PUBLIC UTILITIES COMMISSION

October 6, 2014

RE: Request for Additional Data #2 – Certificate of Public Convenience and Necessity for the Sycamore-Peñasquitos 230-Kilovolt Transmission Line Project – Application No. A. 14-04-011

ATTACHMENT 4

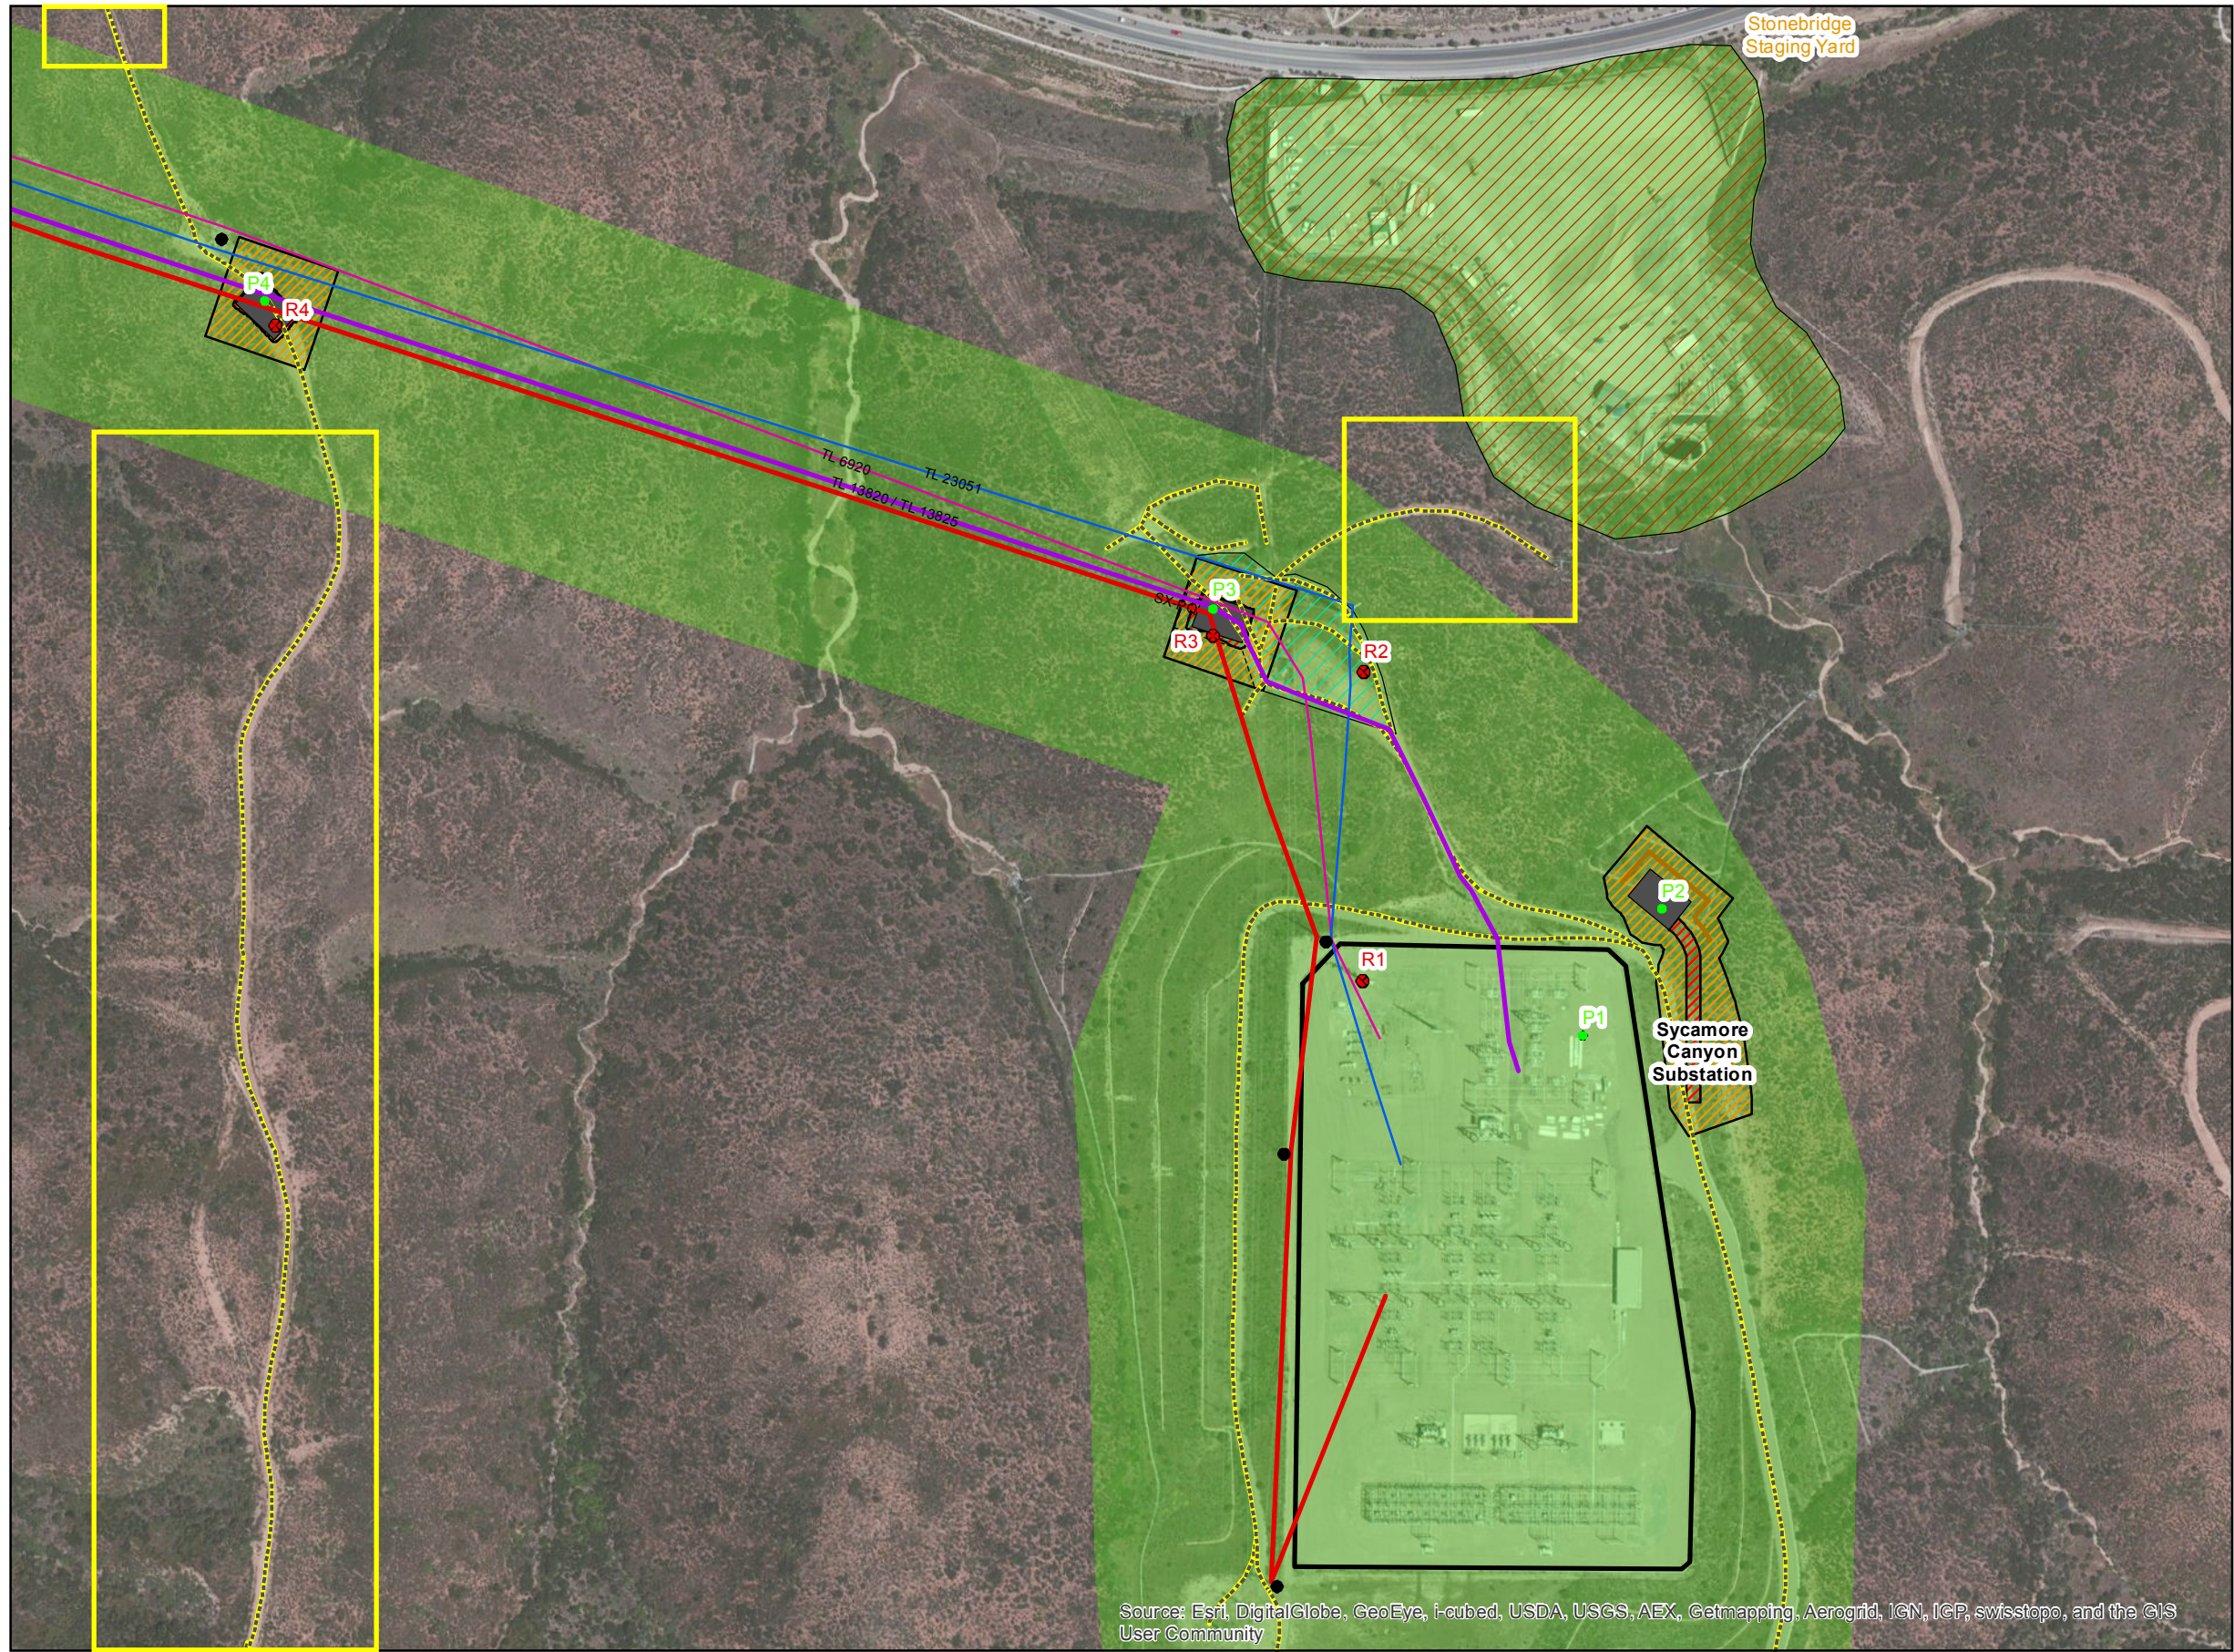
#	PEA Section, Page #	Data Need
90	N/A	There is a large cable strung on the H-frame between the poles just south of Poway Road to the Scripps Summit Business Park (refer to Attachment 4). Its line's catenary is well below the conductor's catenary. What does SDG&E plan to do with this line when the H-frames are removed? Will the line be removed?
Air Quality/Greenhouse Gas Emissions		
91	Air Quality Model	<p>Update the air quality modeling to reflect the increased travel distance to staging yards. Verify all other assumptions in the air quality model are consistent with the Project Description as currently proposed.</p> <p>There have been changes to the project staging yards and Project Description, including construction of large retaining walls, that could affect the assumptions used in the air quality model. The air quality modeling needs to be updated to reflect the current Project Description that accounts for locations of proposed staging yards (with property owner permission) and responses to items in this data request that include, but are not limited to, the total amount of cut-and-fill (import and export of material), locations of landfills, locations of water sources, and duration and type of use of helicopters.</p>
